TITLE: [PR-CM] Terranora Area E - Progress Report on Planning Processes and Major Project Application MP09/0166 for a 300 Lot Residential Subdivision at Lot 40, 43 DP 254416; Lot 2 DP 778727; Lot 1 DP 781687; Lot 1 DP 781697; Lot 1 DP 304649; Lot 1 DP 175235; Lot 1 DP 169490, Parkes Lane, Terranora (DA09/0701)

SUMMARY OF REPORT:

The purpose of this report is to provide Council with an update on the various planning processes currently being undertaken within the urban release area known commonly as 'Area E'.

Figure 1: Sections of the Broadwater Parkway Alignment

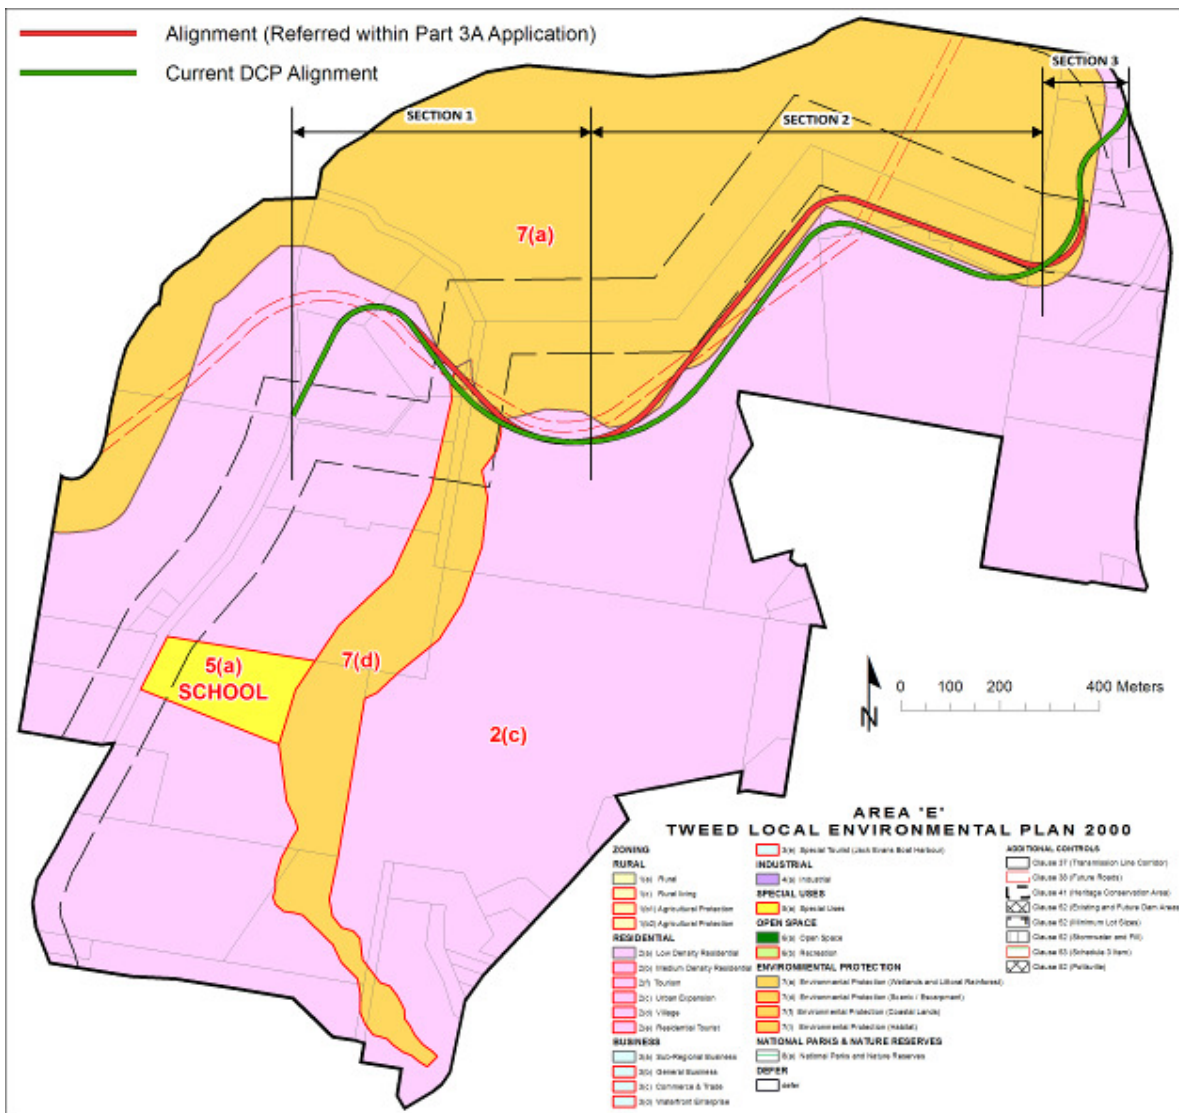
Section 2 of the alignment has been widely debated within the DCP process thus far. Figure 1 demonstrates the two predominate alignment options, the alignment referred within the Part 3A application contained within the 7(a) Environmental Protection zone and the current draft DCP alignment contained within the 2(c) Urban Expansion zone. It is acknowledged that the draft DCP alignment is not formally endorsed by way of Council resolution however within Council’s internal Area E Working Group, no objection has been raised to this alignment to date.

Council's Planning Reform Unit recommends that the draft DCP alignment displayed on Figure 1 be forwarded to DoP to inform their assessment of the Part 3A application and embodied as the benchmark alignment within the draft DCP. The PRU acknowledges that alternative routes may be present, however any other routes investigated by developers of Area E will need to demonstrate that the alternate route provides an

Figure 2 – Part 3A Alignment with Identified Endangered Ecological Communities

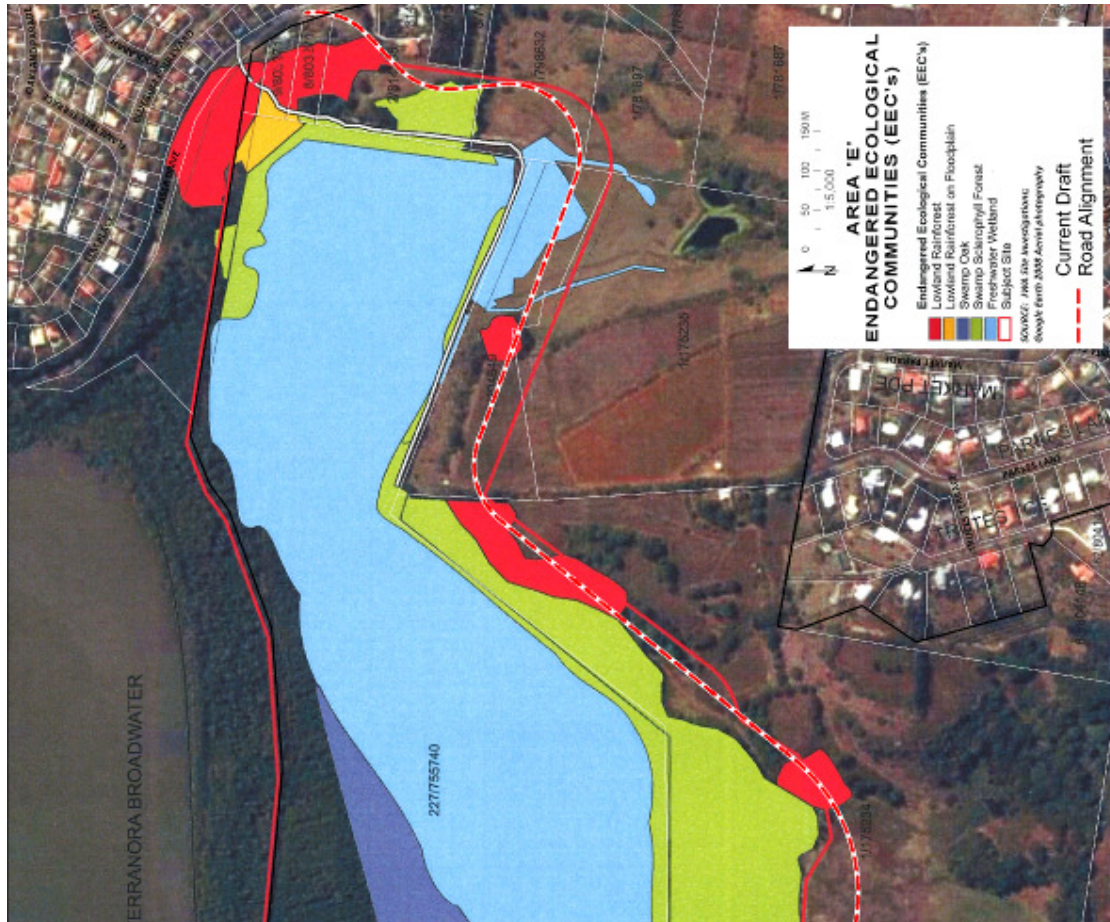
When considering the Part 3A alignment, the alignment traverses the Environmental Protection zone for approximately 1,108 metres. Within this length, two Endangered Ecological Communities (EECs) are intersected on five occasions. The EECs identified include Lowland Rainforest and Freshwater Wetland. Figure 2 shows the Section 2 alignment over these EECs, the mapping for which was prepared by James Warren and Associates, and previously submitted to Council by Metricon. This alignment is not considered to be a desirable outcome. The current DCP alignment contains the road infrastructure within the urban zone, providing reduced environmental impacts.

Investigations into Section 3 have revealed that there are a number of constraints at the eastern end of the road alignment which influenced the final alignment. This component of the alignment is therefore considered to possess an ability to satisfy the provisions of Clause 8(2) as it demonstrates that there is no other appropriate site on which the development can be permitted. Section 2 however is not restricted in the same way. Further, Council has demonstrated through the ongoing DCP preparation process that alternative sites on which the development is permitted are available. Accordingly, the

alignment within the Environmental Protection zone is considered prohibited as it relates to this site.

Diagram 1 - Stage 4 priority route alignment - Drawing No. E-01

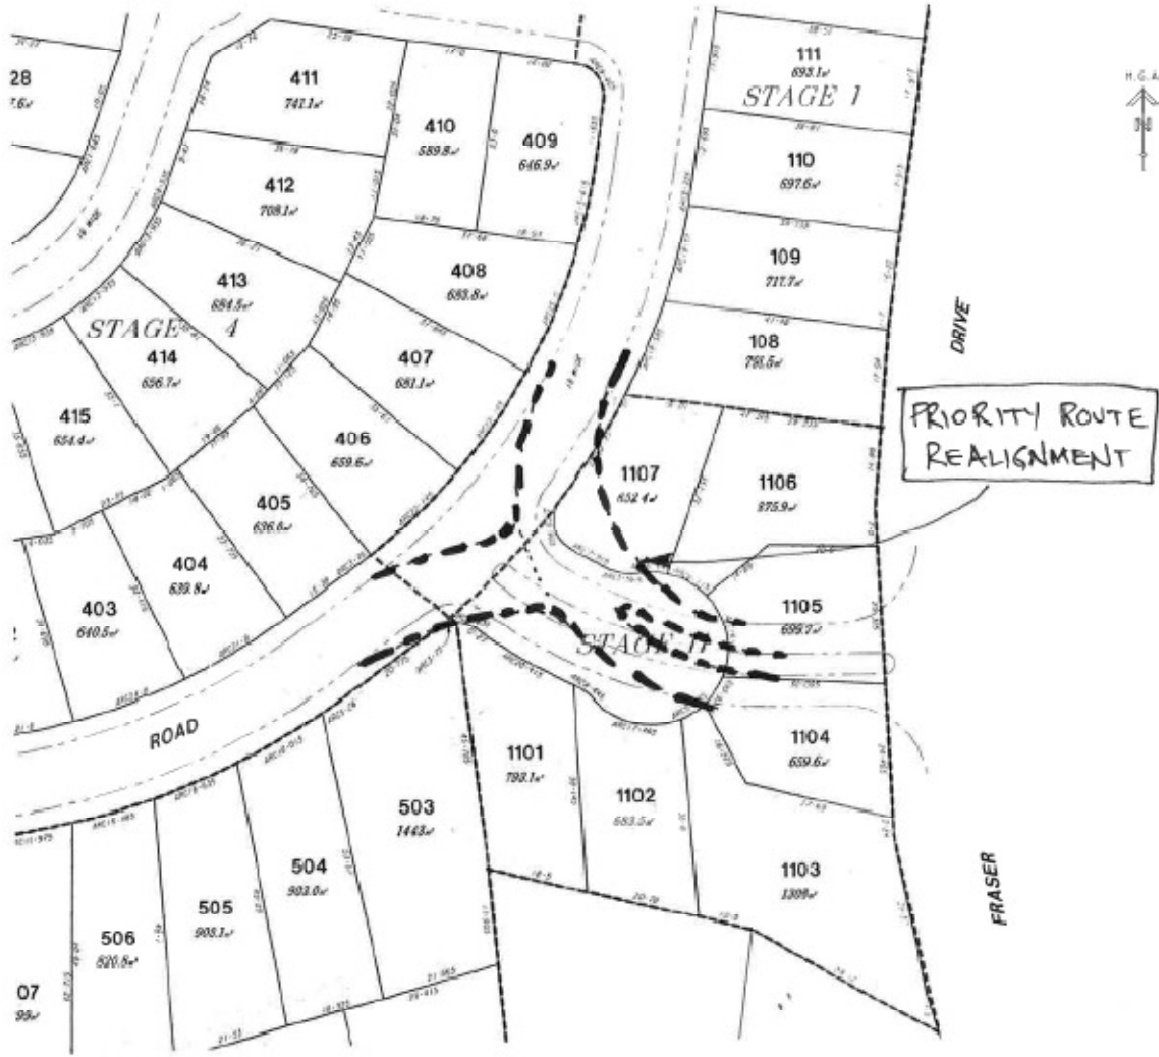
Any consent for the development must include a condition which requires that the connection road from Fraser Drive which meets the main internal road in Stage 4 must be realigned generally in accordance with Drawing No. E-01 (refer to Diagram 1 below) or a roundabout is to be constructed at the intersection of the connection road from Fraser Drive and the main internal road in Stage 4.

Figure 7: Mapped Lowland Rainforest EEC on the proposal site (JWA 2008 & 2010)

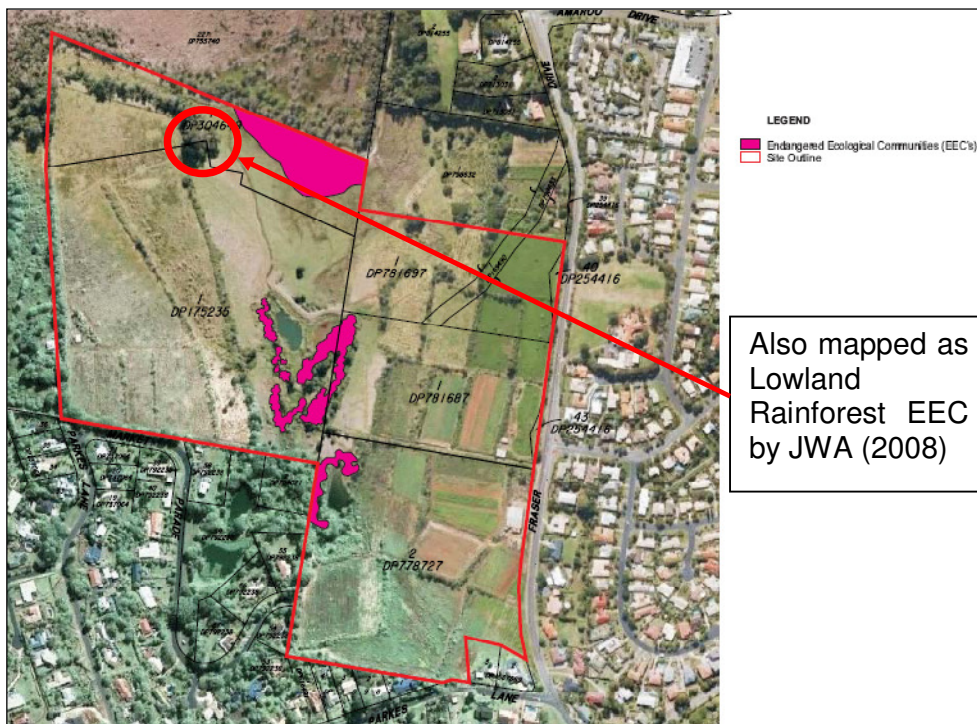
Whilst it is noted in the Ecological Assessment that occurrences of this EEC are regrowth and disturbed, and it is also acknowledged that this area is quite fragmented, the species list of this community indicates high diversity including less common plant species and species that typically occur in more intact stands of rainforest. The species list also notes the occurrence of five Rare or Threatened Australian Plants (as per Briggs & Leigh 1996) including Silverleaf (*Argophyllum nullemense*), Black Walnut (*Endiandra globosa*), Veiny Lace Flower (*Archidendron muellerianum*), Ardisia (*Ardisia bakeri*) and Long-leaved Tuckeroo (*Cupaniopsis newmanii*). No assessment has been undertaken on whether the development will impact on these ROTAPs.
